HEARING DATE: February 1, 2024

TO: Planning & Zoning Commission

FROM: Sonya Allen, Associate Planner
208-884-5533

SUBJECT: Stonehill Church – MDA, RZ, PP, CUP
[H-2023-0041](#)

B. Preliminary Plat (dated: 7/6/23) & Roundabout Exhibit

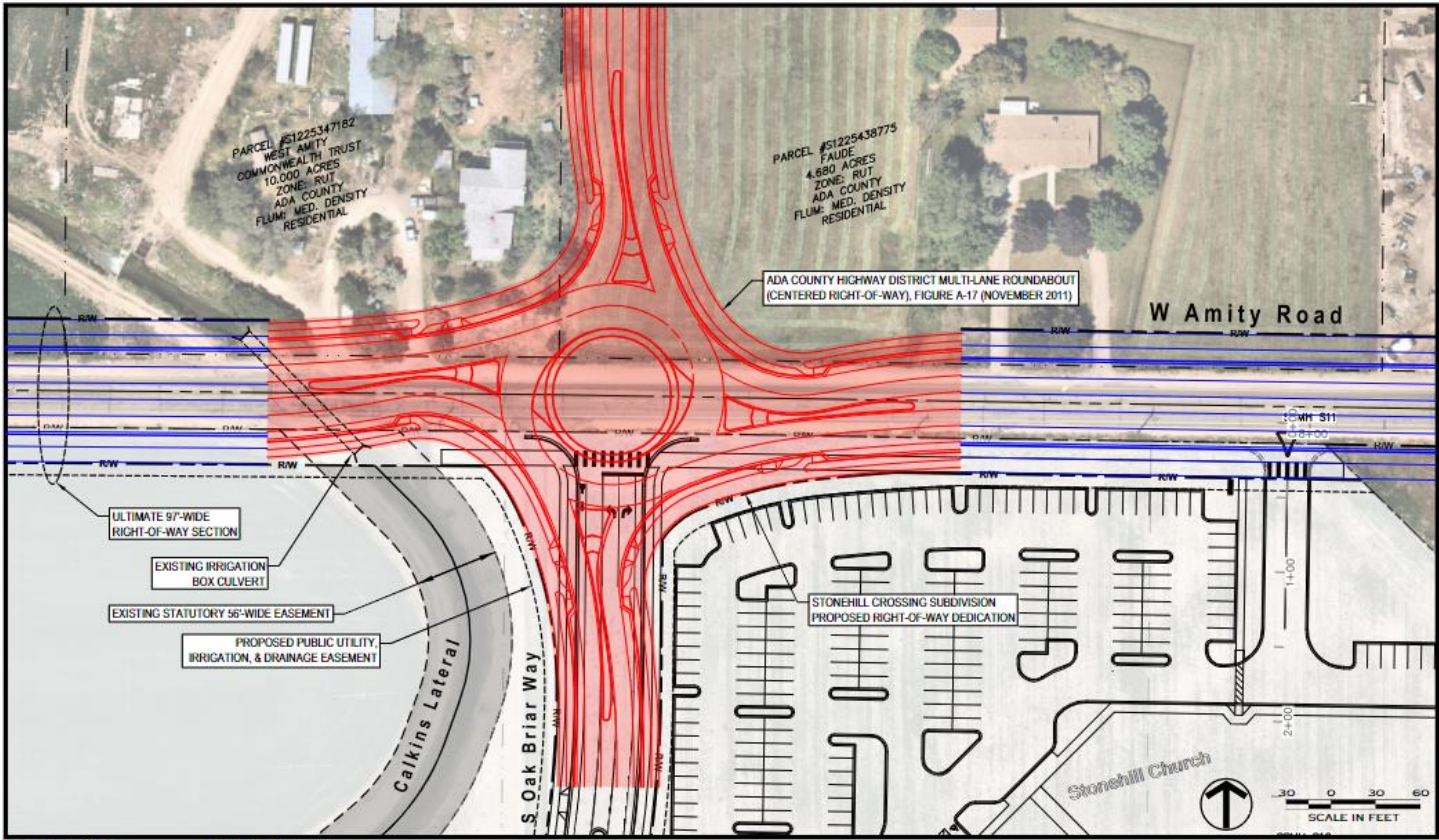
A collector street is proposed as depicted on the plat from W. Amity Rd. at the northern boundary of the site extending to the southern boundary of the site in accord with the Master Street Map (MSM). **A temporary cul-de-sac is required to be constructed at the terminus of the collector street at the south boundary with a minimum turning radius of 50' as required by ACHD.**

The MSM also depicts a multi-lane roundabout at the Amity Rd./Oak Briar Way intersection. The Applicant is required to dedicate right-of-way (ROW) for construction of the roundabout consistent with the template shown in the ACHD report. A roundabout exhibit was submitted, included in Section VIII.B, in accord with this template.

Because a subdivision is proposed, Staff recommends a street is constructed from the collector street (Oak Briar) between Lots 1 and 2, Block 1 to provide local street access to the church and the existing residence. A cul-de-sac or ACHD/Fire Dept. approved turnaround should be provided at the end of the street, which should extend to at least the eastern boundary of Lot 2, Block 1 but may extend further depending on the access needs of the church. This street should be extended in the future with resubdivision of Lot 3, Block 1.

- 2.1 The final plat shall include the following revisions:
- a. Depict a minimum 25-foot wide street buffer along W. Amity Rd., an arterial street, in a common lot or a permanent dedicated buffer easement maintained by the property owner in accord with UDC [11-3B-7C.2a](#). The buffer shall be measured from the ultimate curb location as anticipated by ACHD.

- b. Depict a minimum 20-foot wide street buffer along both sides of S. Oak Briar Way, a collector street, measured from back of curb, in a common lot or a permanent dedicated buffer easement maintained by the property owner or homeowner's association in accord with UDC [11-3B-7C.2a](#).

- c. Depict a temporary cul-de-sac at the south end of the collector street (S. Oak Briar Way) with a minimum turning radius of 50' as required by ACHD.

- d. Graphically depict a 14' wide public pedestrian easement along the Calkins Lateral on Lot 1, Block 2 and include the recorded instrument number of the easement.

- g. Depict a local street off S. Oak Briar Way between Lots 1 and 2, Block 1 for local street access to these lots in accord with UDC 11-3A-3. This street shall extend at a minimum, to the east boundary of Lot 2, Block 1 and shall be extended with future resubdivision of Lot 3, Block 1 in

C. Preliminary Plat - Landscape Plan (dated: 9/25/2023)

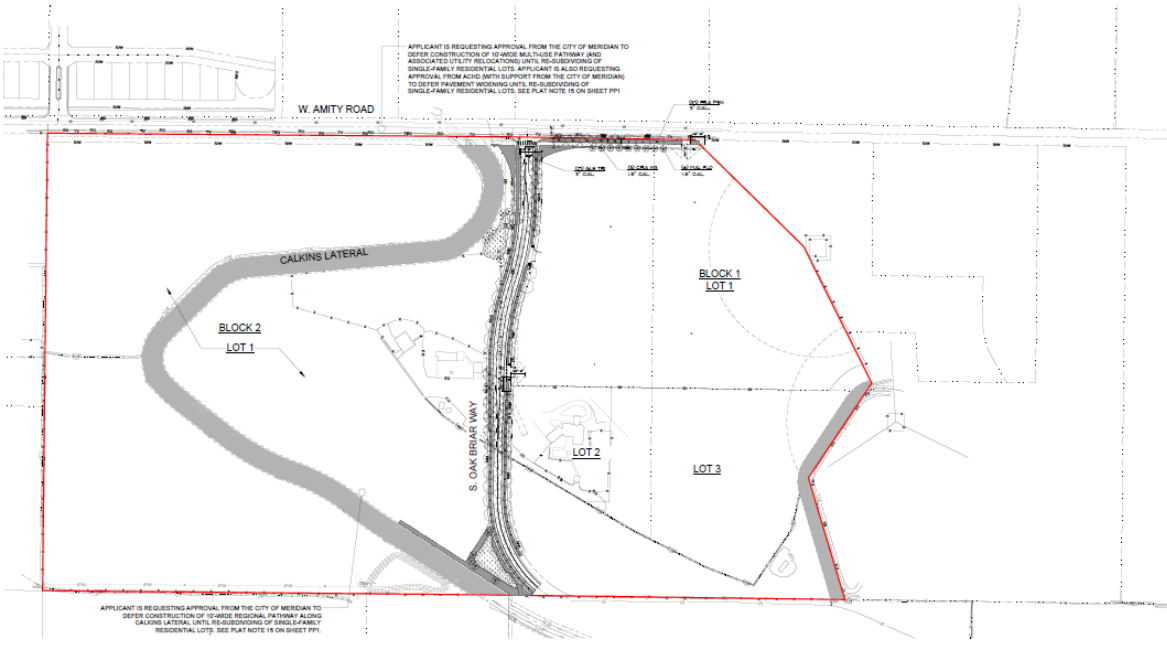
Landscaping: A 25-foot wide street buffer is required along W. Amity Rd., an arterial street, measured from *ultimate* back of curb location; and a 20-foot wide street buffer is required along S. Oak Briar Way measured from back of curb. **Landscaping is required to be installed within the buffers in accord with the standards listed in UDC [11-3B-7C.3](#); the proposed landscape plan should be revised to comply with these standards.**

Fencing: All fencing is required to comply with the standards listed in UDC [11-3A-6C](#) and [11-3A-7](#). Fencing is not depicted on the landscape plan.

- a. Depict landscaping within the 20' wide street buffer along S. Oak Briar Way; and within the 25-foot wide street buffer along W. Amity Rd. on Lot 1, Block 1 in accord with the standards listed in UDC [11-3B-7C.3](#). *The street buffer along Amity Rd. on Lot 1, Block 2 is deferred until future resubdivision of that lot.*

- b. Include a calculations table that demonstrates compliance with the aforementioned street buffer requirements, including required vs. provided number of trees, percentages and tree classifications.

- c. Landscaping shall be depicted in parkways in accord with the standards listed in UDC [11-3A-17E](#).
- 2.3 All existing structures that do not comply with the setbacks of the R-4 zoning district in UDC [Table 11-2A-5](#) shall be removed from the site prior to submittal of the final plat for City Engineer signature.

D. Conceptual Development Plan for Future Resubdivision of Lot 3, Block 1 & Lot 1, Block 2

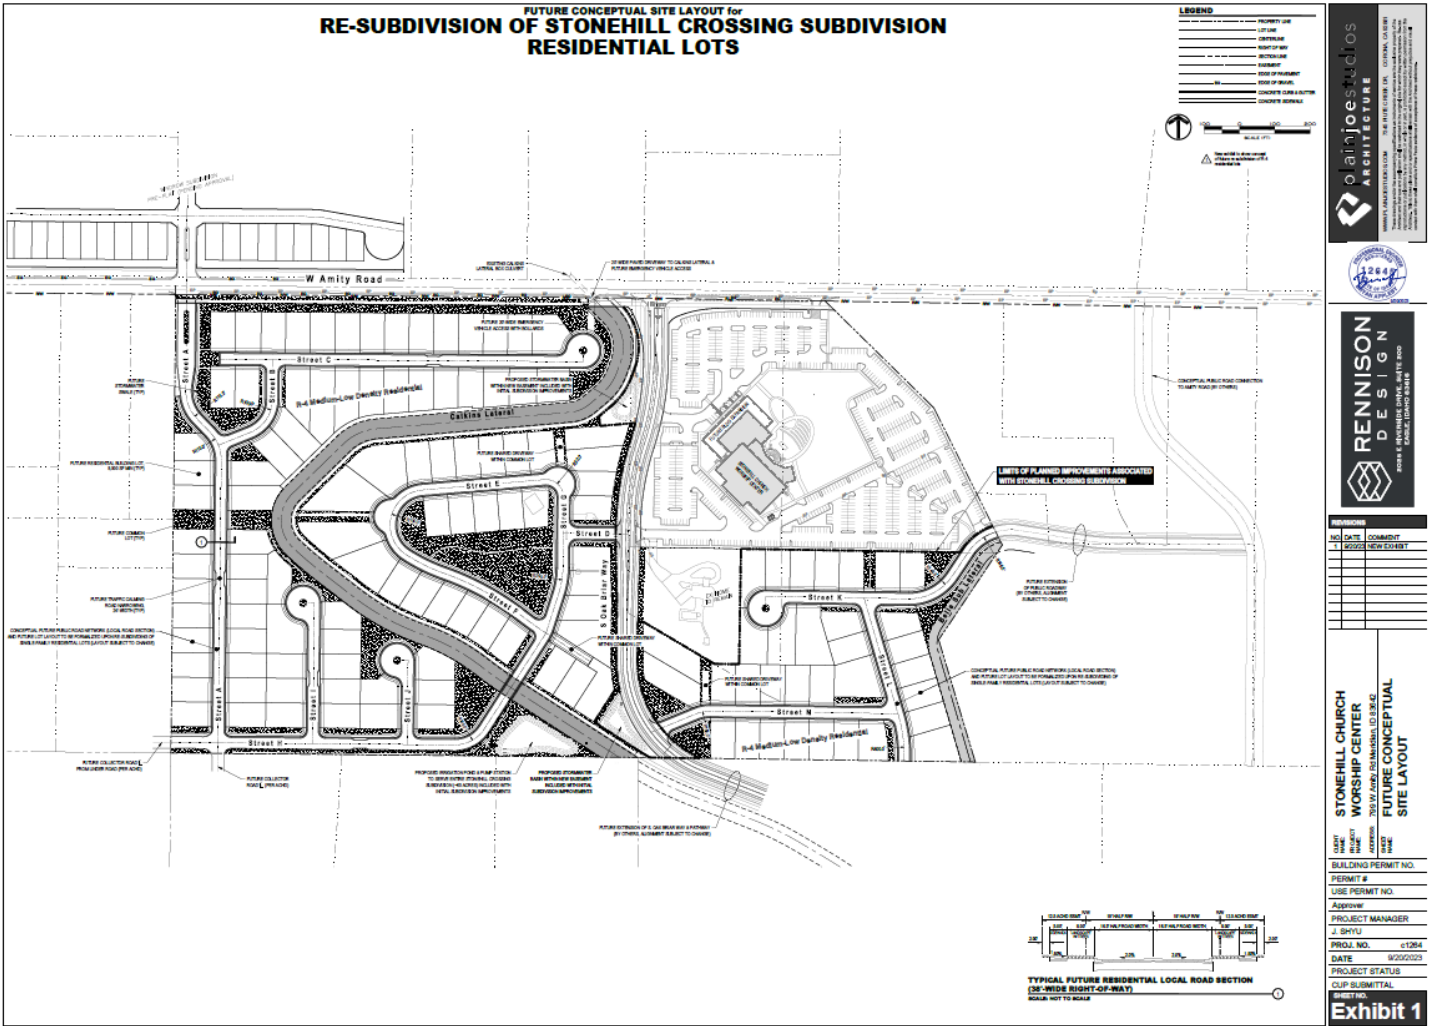
Conceptual Development Plan for Resubdivision: A conceptual development plan was submitted for a possible site layout for the future resubdivision of Lot 3, Block 1 and Lot 1, Block 2, as shown in Section VII.D. Future development is not tied to this plan as a DA modification is not proposed or required with this application. However, requested a development plan be submitted for this area for consideration. Staff offers the following comments on this plan:

- Dead end streets (i.e. Street C) should not be longer than 500'; however, City Council may approve a dead end street up to 750' in length where an emergency access is proposed or a large waterway exists that prevents or makes impractical the extension or other conditions exists as noted in UDC [11-6C-3B.4](#). Although an emergency access via W. Amity Rd. is proposed and there is a large waterway that exists at the east end of the street, the dead end street exceeds 750' at 870' in length.

- Block faces are limited to 750' in length without an intersecting street or alley, except Council may approve a block face up to 1,200' where block design is constrained by site conditions such as an abutting arterial street or a large waterway and/or irrigation facility, among other conditions. The block face on the north side of Street C exceeds the minimum block face length allowed and would require approval from City Council as proposed.

- Stub streets should be provided to adjacent parcels for future extension and interconnectivity. A collector street is no longer required at the west end of the site along the southern boundary as the collector street has been moved to the south in alignment with Quartz Creek St. and is no longer needed in this location.

- The Applicant should consult the Irrigation District to see if a pedestrian bridge will be allowed across the Calkins Lateral.
- A local street should be provided between Lots 1 and 2, Block 1 from S. Oak Briar St. to the east end of Lot 2, Block 1, at a minimum, to reduce access points on the collector street and in accord with UDC [11-3A-3A.3](#), which requires all subdivisions to provide local street access to any use that currently takes direct access from an arterial or collector street.

- The Calkins Lateral and the Belle Sub Lateral are required to be piped unless used as a water amenity or linear open space as defined in UDC [11-1A-1](#) per UDC [11-3A-6B](#). The decision-making body may waive this requirement if it finds that the public purpose requiring such will not be served and public safety can be preserved.

- If the Calkins Lateral and the Belle Sub Lateral are approved to be left open and not required to be piped and not improved as a water amenity or linear open space as noted above, fencing will be required to deter access to the laterals for public safety per the standards listed in UDC [11-3A-6C](#).

- Common open space and site amenities will be required in accord with the standards set forth in UDC [11-3G-3](#) and [11-3G-4](#).
- Access to the collector (i.e. S. Oak Briar Way) and arterial streets (i.e. W. Amity Rd.) is limited as set forth in UDC [11-3A-3A](#), unless otherwise waived by City Council.

E. Conditional Use Permit – Site Plan & Phasing Plan (dated: 7/6/2023)

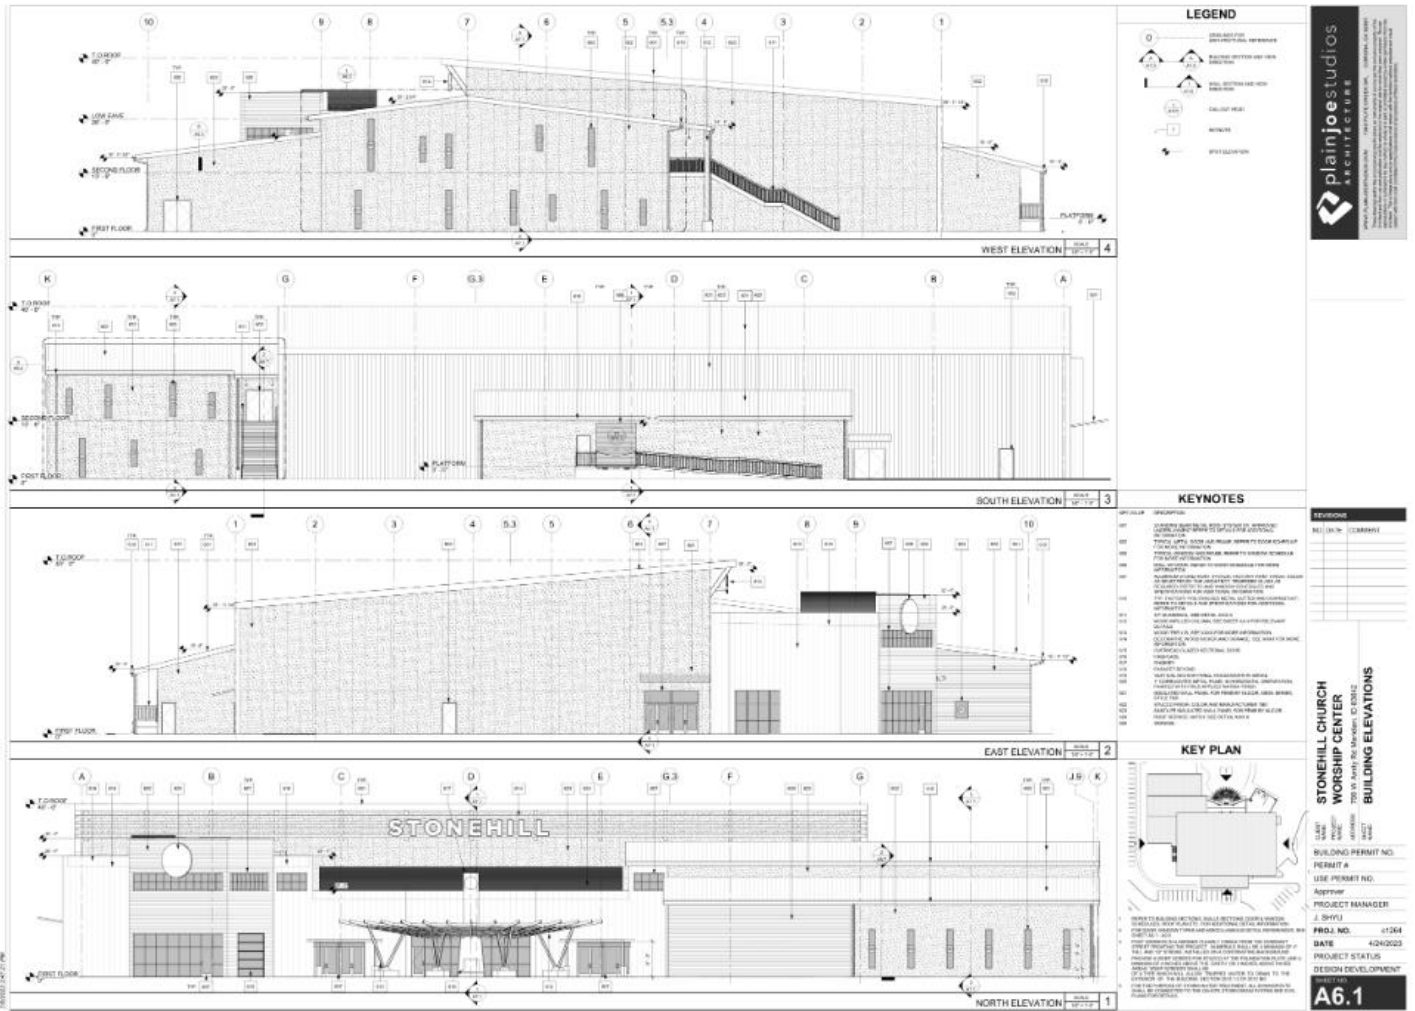
Phasing: The church (and associated drive aisles, parking and landscaping) is proposed to develop in two (2) phases as shown on the phasing plan in Section VIII.E. The first phase will consist of approximately 40,000 s.f. and the second phase will consist of approximately 12,000 s.f.

Pathway/walkway: A 5' wide pedestrian walkway is proposed as required from the perimeter sidewalk along Amity and Oak Briar to the main building entrance of the church in accord with UDC [11-3A-19B.4](#). **The walkways should be distinguished from the vehicular driving surface through the use of pavers, colored or scored concrete, or bricks.**

Minimum 5' wide walkways should be provided in the parking area for any aisle length that is greater than 150 parking spaces or 200' away from the primary building entrance(s) as set forth in UDC [11-3A-19B.4c](#).

Pedestrian connections with pathways should be provided from the church site to future abutting residential uses to the east and south for interconnectivity.

Parking: Off-street parking is required to be provided based on the square footage of the church per the standards set forth in UDC [11-3C-6B.1](#) for commercial districts (i.e. 1 space for every 500 s.f. of gross floor area). Based on a total of 52,000+/- s.f., including the future addition, a minimum of 104 spaces will be required. The Applicant proposes to provide 545+/- spaces with the first phase and 269+/- spaces with the second phase, which *exceeds* the minimum standards by 710+/- spaces.

Parking stalls and drive aisles should comply with the dimensions noted in UDC [Table 11-3C-5](#). Where parking spaces abut a sidewalk or a perimeter landscape buffer, wheel stops should be provided to prevent vehicle overhang *or* the length of the parking space may be reduced 2' if an additional 2' is added to the width of the sidewalk or the perimeter buffer to total 7' as set forth in UDC [11-3C-5B.4](#). **The site plan submitted with the Certificate of Zoning Compliance application should depict dimensions that demonstrate compliance with these standards.**

- 3.1 The site plan and landscape plan submitted with the Certificate of Zoning Compliance application shall be revised as follows:
 - a. All outdoor utility meters, HVAC equipment, trash dumpsters, trash compaction and other service functions shall be incorporated into the overall design of buildings and landscaping so that the visual and acoustic impacts of these functions are fully contained and out of view from adjacent properties and public streets as set forth in UDC [11-3A-12](#). Safe access and adequate lighting should be provided in these areas.

- f. Depict dimensions for parking stalls and drive aisles that comply with the dimensions noted in UDC [Table 11-3C-5](#). Where parking spaces abut a sidewalk or a perimeter landscape buffer, wheel stops should be provided in parking stalls to prevent vehicle overhang; *or*, the length of the parking stalls may be reduced 2' if an additional 2' is added to the width of the sidewalk or the perimeter buffer to total 7' as set forth in UDC [11-3C-5B.4](#).
